ADDENDUM NO. 2

DATE: October 19, 2020

For
DYPISKI PARK IMPROVEMENTS
CONTRACT NO. RP 17802R

FOR THE MAYOR AND CITY COUNCIL OF BALTIMORE

Job No.	17802R	FHP	Drawn
Scale	AS SHOWN	CMS	Checked
Date	9/25/2020	JAC	Approved
Drawing Title	PROPOSED UTILITY PLAN		
Sheet	C1.1r		Of

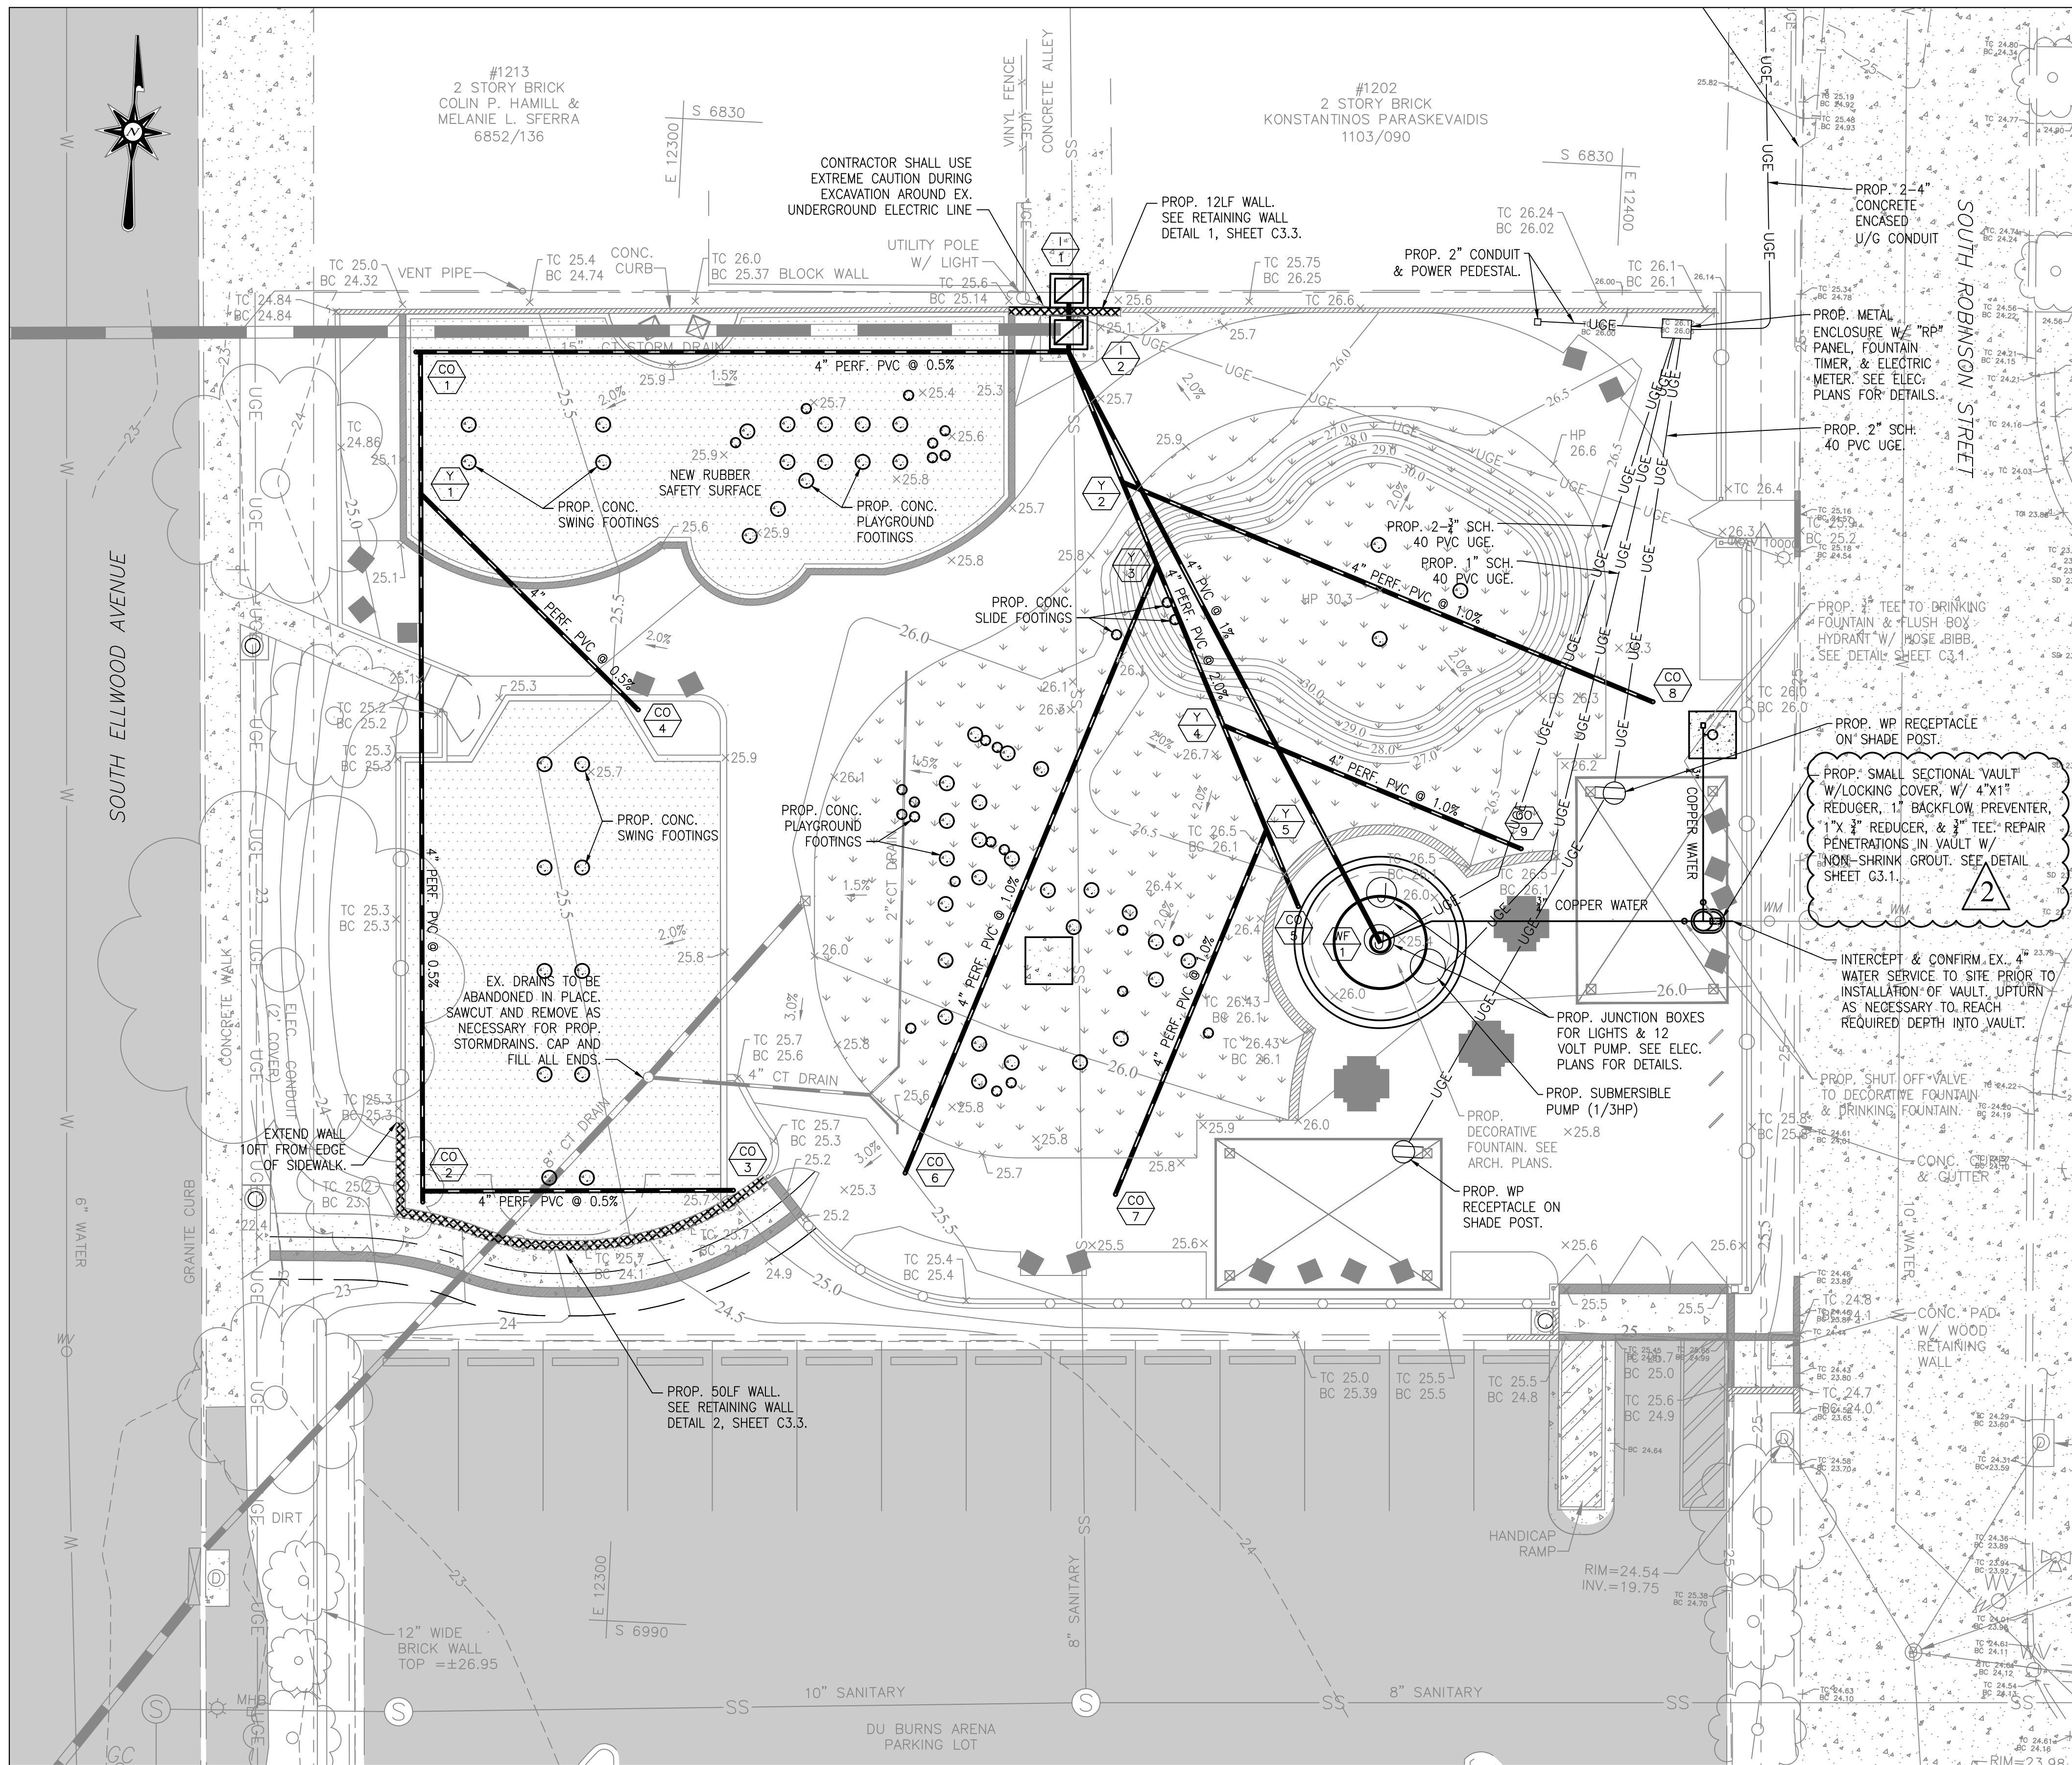
Item No.	SHEET No.	DESCRIPTION OF CHANGES
2.1	C1.1r (Vol # 1 dwgs.)	DELETE sheet C1.1 and REPLACE sheet C1.1r Proposed Utility Plan
2.2	C3.1r (Vol # 1 dwgs.)	DELETE sheet C3.1 and REPLACE sheet C3.1r Civil Details 1
2.3	C3.2r (Vol # 1 dwgs.)	DELETE sheet C3.2 and REPLACE sheet C3.2r Civil Details 2
2.4	L1.1r (Vol #2 dwgs.)	DELETE sheet L1.1 and REPLACE sheet L1.1r Pavilion Erection Roof Details
2.5	A1.0r (Vol #2 dwgs.)	DELETE sheet A1.0 and REPLACE sheet A1.0r Pavilion Erection Plans
2.6	A1.1r (Vol #2 dwgs.)	DELETE sheet A1.1 and REPLACE sheet A1.1r Pavilion Erection Plans
2.7	A1.2r (Vol #2 dwgs.)	DELETE sheet A1.2 and REPLACE sheet A1.2r Pavilion Erection Elevations
2.8	A3.1r (Vol #2 dwgs.)	DELETE sheet A3.1 and REPLACE sheet A3.1r Pavilion Erection Roof Details
2.9	A4.1r (Vol #2 dwgs.)	DELETE sheet A4.1 and REPLACE sheet A4.1r Comfort Station Improvements

CITY OF BALTIMORE DEPARTMENT OF RECREATION AND PARKS		DRAWN BY <u>L. DECKER</u>
DEMOLITION PLAN AND PHOTOGRAPHS (PAVILION)		TRACED BY _____
SCALE <u>NTS</u>		DESIGNED BY _____
DATE <u>September 25, 2020</u>		CHECKED BY _____
		PROJECT NO. SHEET NO. RP17802R L1.1r

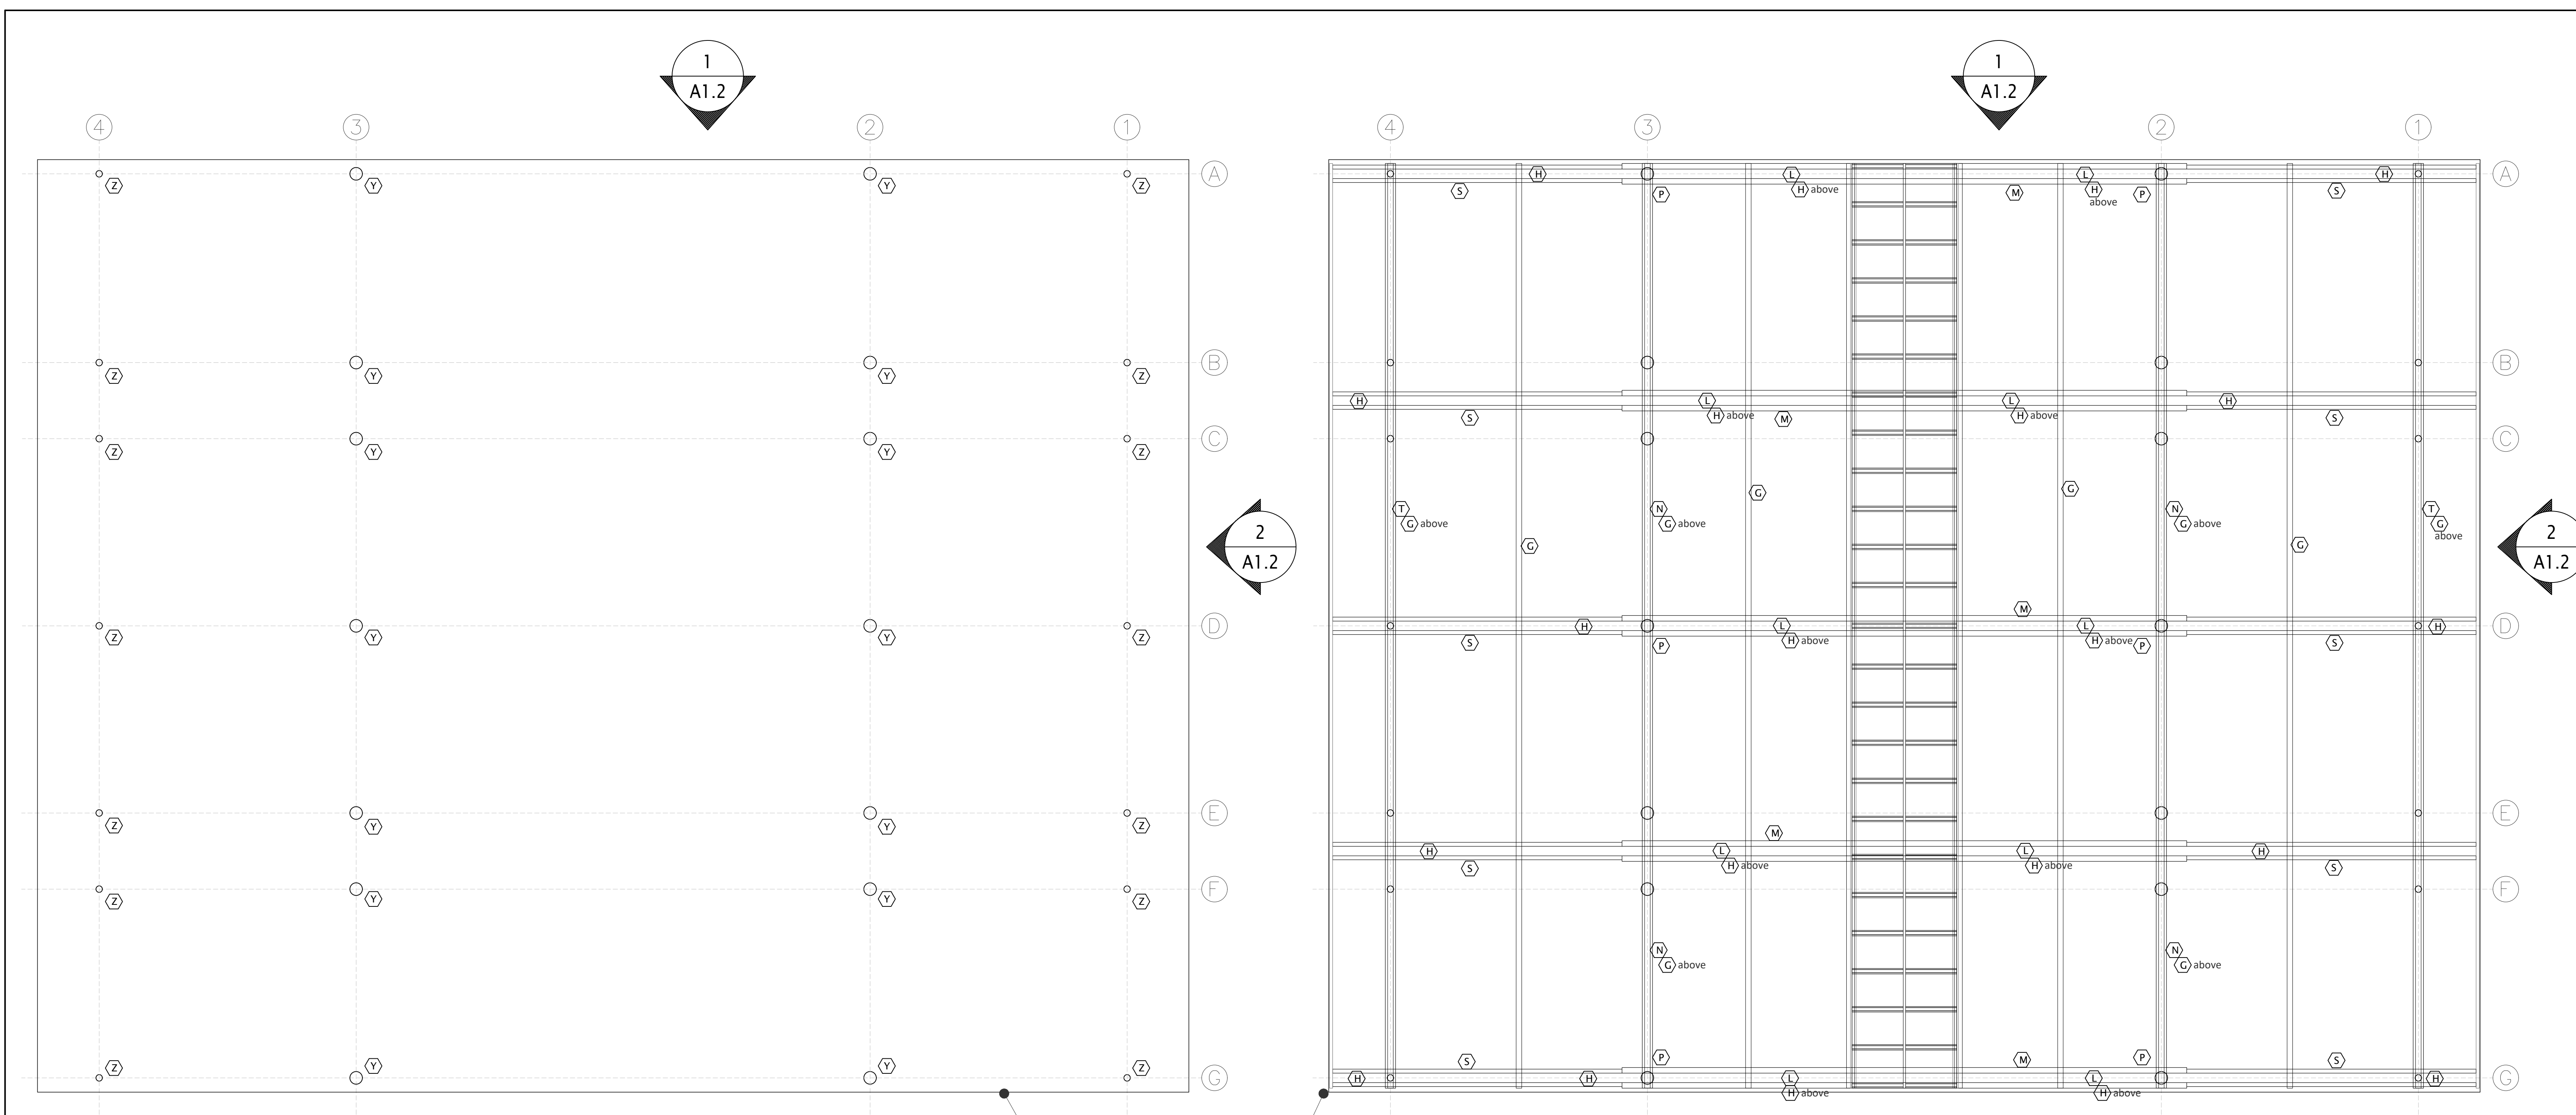
QUESTION 16: Clarify the symbol / item “E. Clerestory framing- see detail photo” in how it is associated with any clerestory openings’ improvements?

ANSWER: **As with all portions of the existing structure, GC is to document the existing and then provide shop drawings describing the intent for re-erection. Applied to the Clerestory, (part of the Existing Historic Structure) it is the exact same process. As per demolition drawings the metal panel covering added in the 1980’s is to be demolished. Just like every other part of the existing historic structure, in the shop drawing submittal include framing and details of the Clerestory.**
